Borough of Bergenfield
Site Plan Committee Minutes
March 8, 2021

Sixboro Holdings
40 Hickory Avenue
Bergenfield, NJ 07621

Site Address 40, 44,46,48Hickory Avenue
Seeks to build 18 unit Townhouse with 4 affordable rental units Seeking Use Change, and 5 bulk variances.

GRADING AND DRAINAGE PLAN

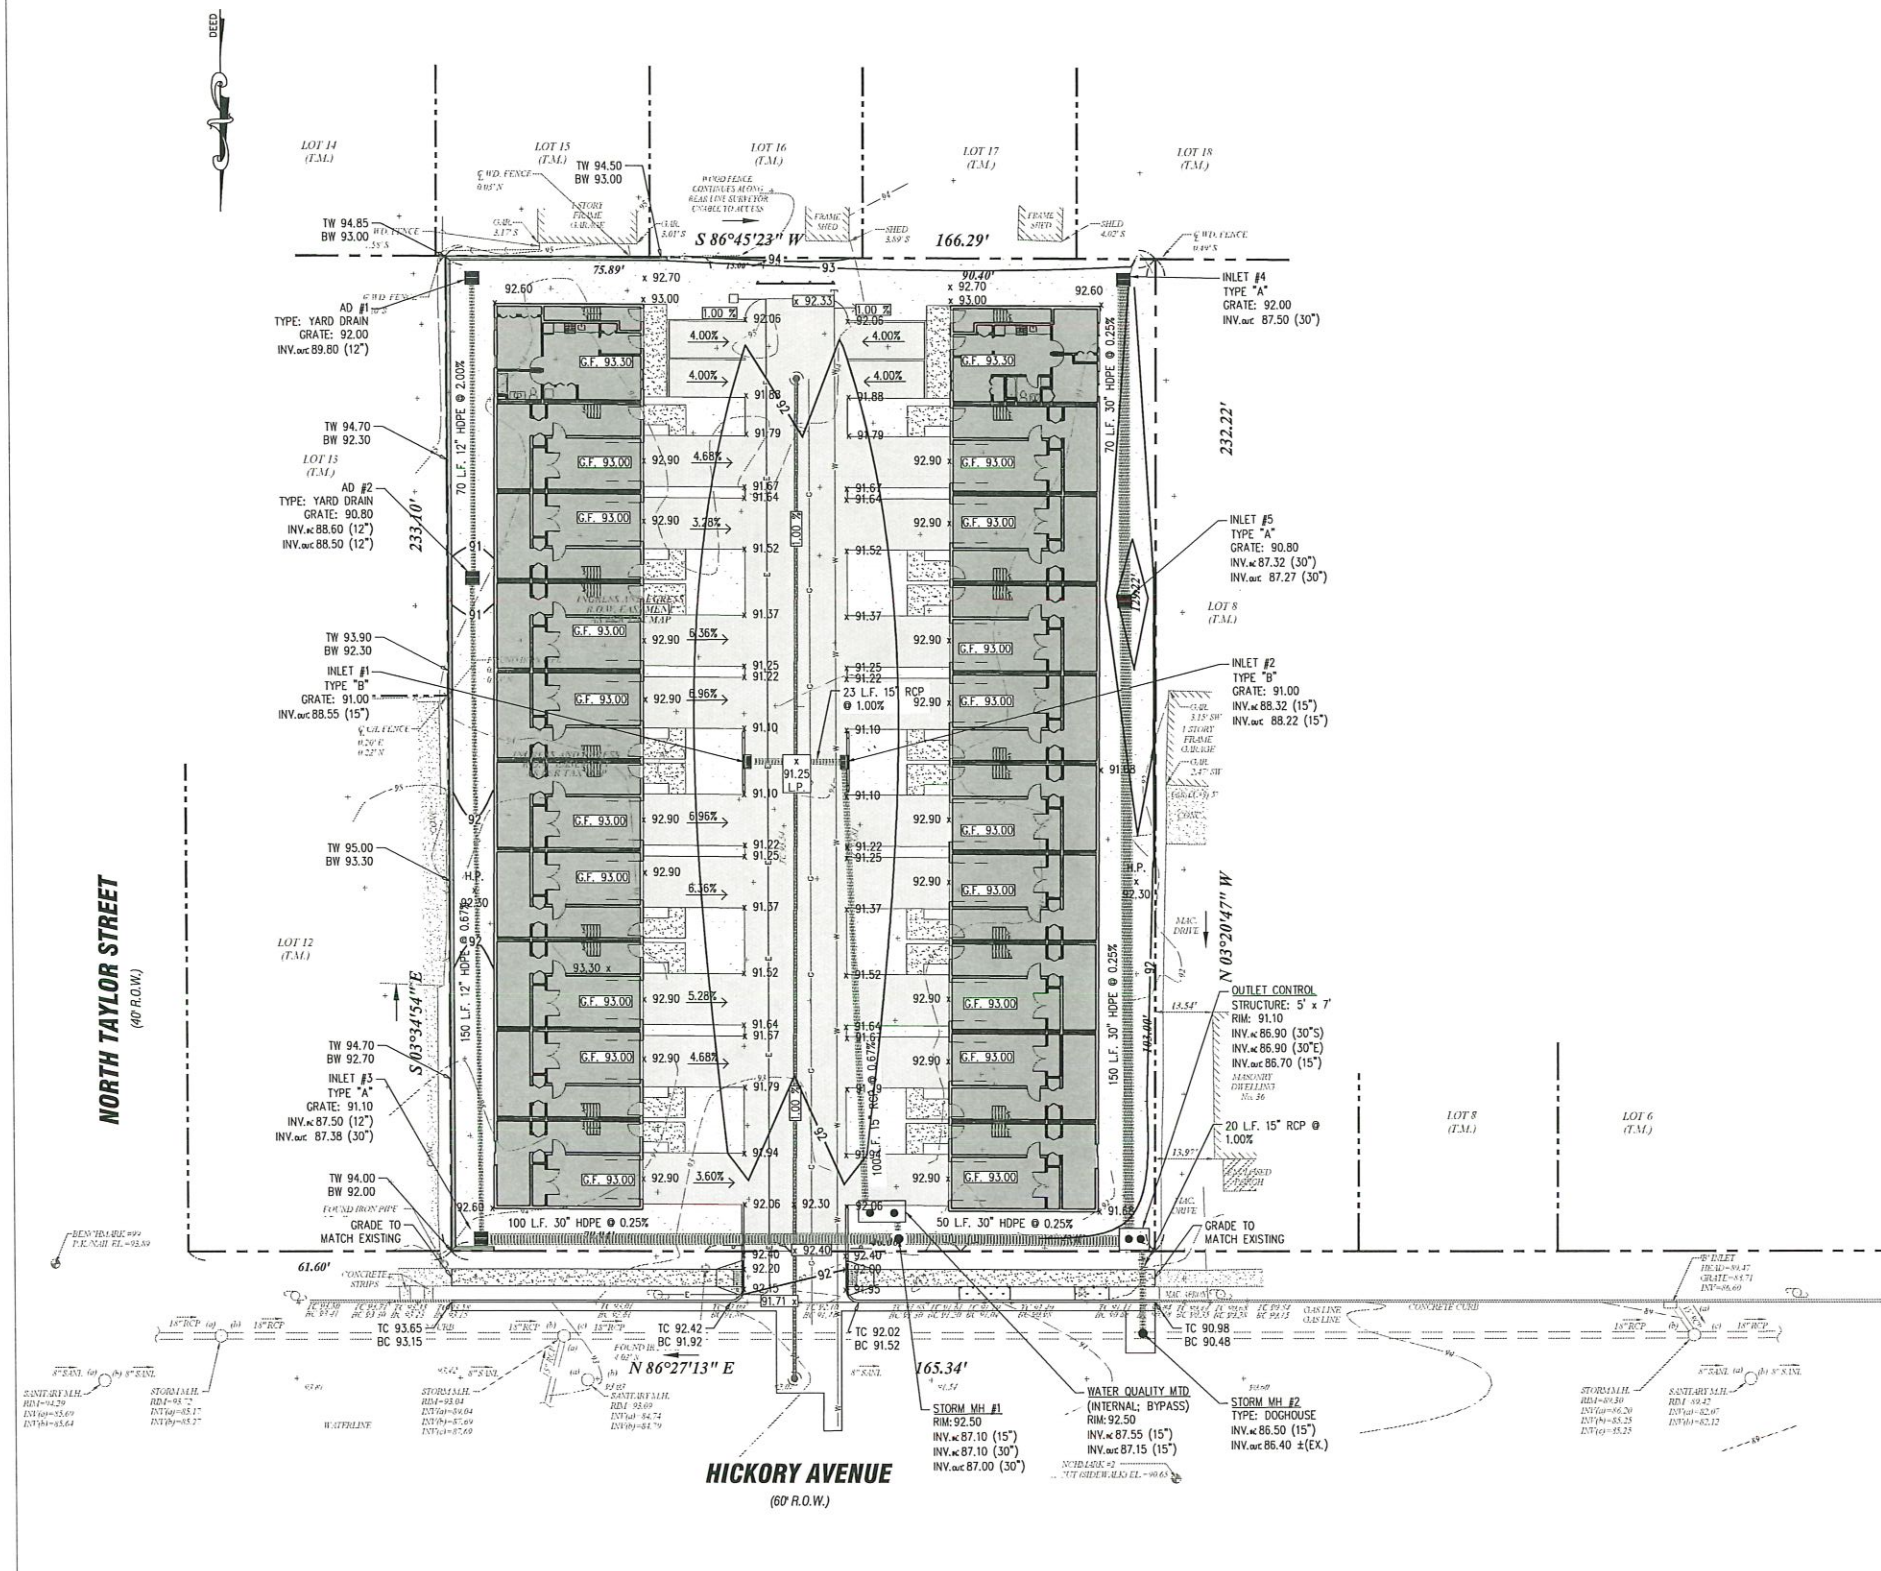
- 150' maximum distance for fire truck without a turn around
- Fire hydrant at rear of property, should be closer to Hickory
- Consider flow requirements at hydrant
- Sprinkler system with a FDC at Hickory is what the FD would prefer
- Eliminate 2 rear units to accommodate turn around.

- Fire hydrant connections are to 4" national standard
- Move hydrant to Hickory Avenue
- Hydrant must be red, not yellow

- I will discuss all the recommendations with my client
- The attic spaces will be separated

BUILDING ELEVATIONS - 1 OF 2

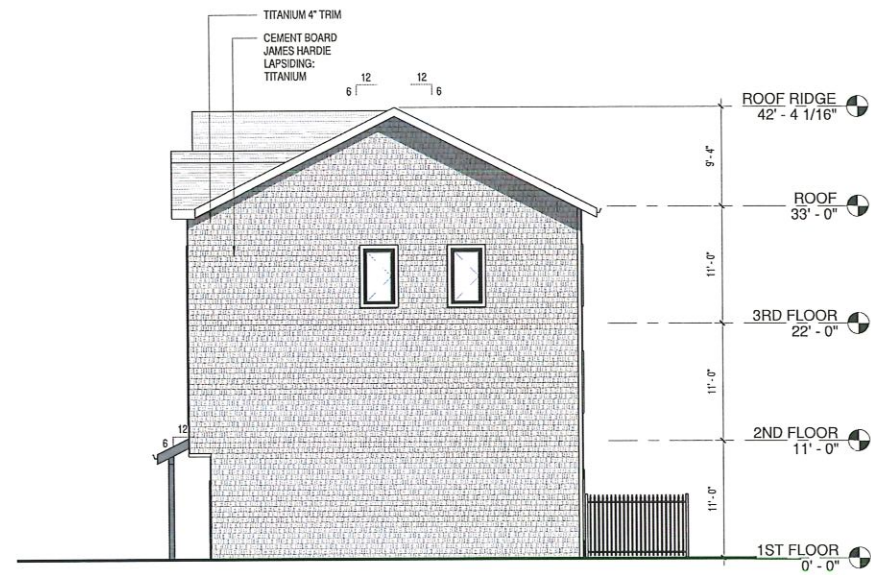
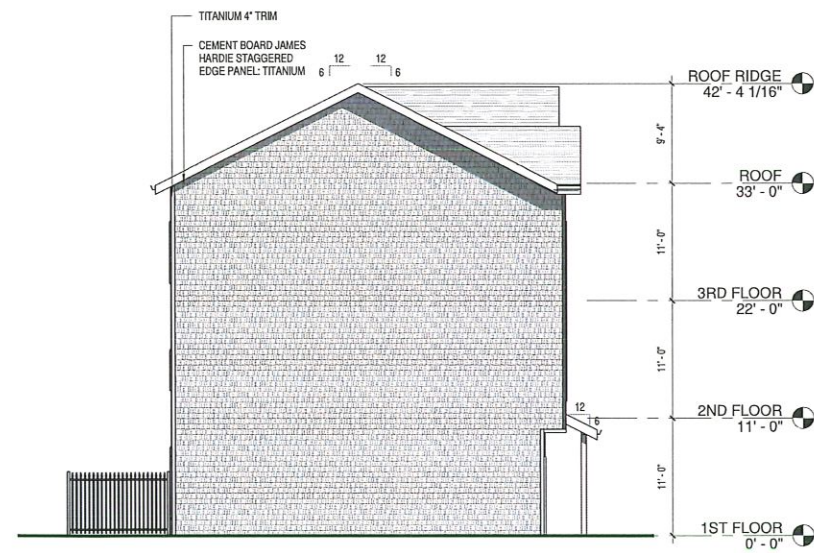
- Questions visitor parking spaces
- Height of building is well over limit
- Lot coverage was over limit

- The height of the building on the plans is to the top of the ridge, if measured to the mean height of the roof it becomes very close to the 35 Limit for a R-M use.
- Overflow visitor parking will have to be on Hickory Avenue
